**MONTGOMERY COUNTY HISTORIC PRESERVATION COMMISSION**  
**STAFF REPORT**

| <b>Address:</b>     | 7818 Overhill Rd., Bethesda  | <b>Meeting Date:</b>  | 5/14/2025    |
| <b>Case Number:</b> | 1111949  | <b>Staff:</b>         | Devon Murtha |
| <b>PROPOSAL:</b>    | Window Replacement   |                       |              |

Figure 4: Detail of proposed simulated divided lite profile.

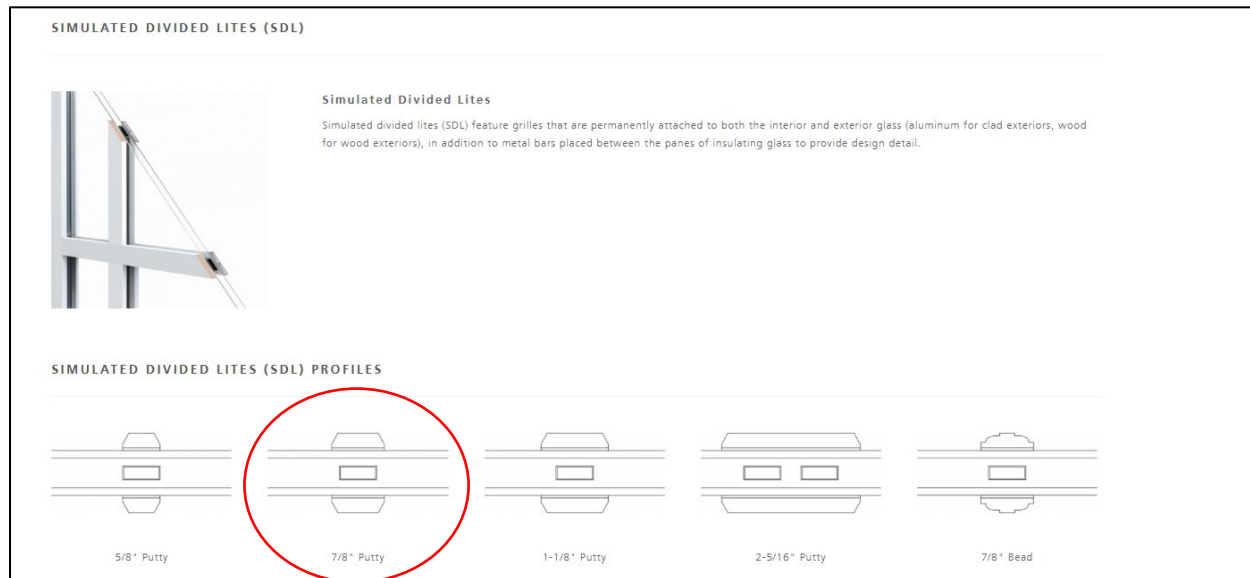
The applicant proposes to remove ten (10) wood windows on the front and side elevations of the house. These windows will be replaced with double-hung aluminum-clad wood windows. The proposed windows are the Sitaline windows made by Jeld-Wen, which include 7/8" putty simulated divided lites. These are a similar profile to the clad windows that were approved by the HPC as part of the 2019 addition.<sup>1</sup>
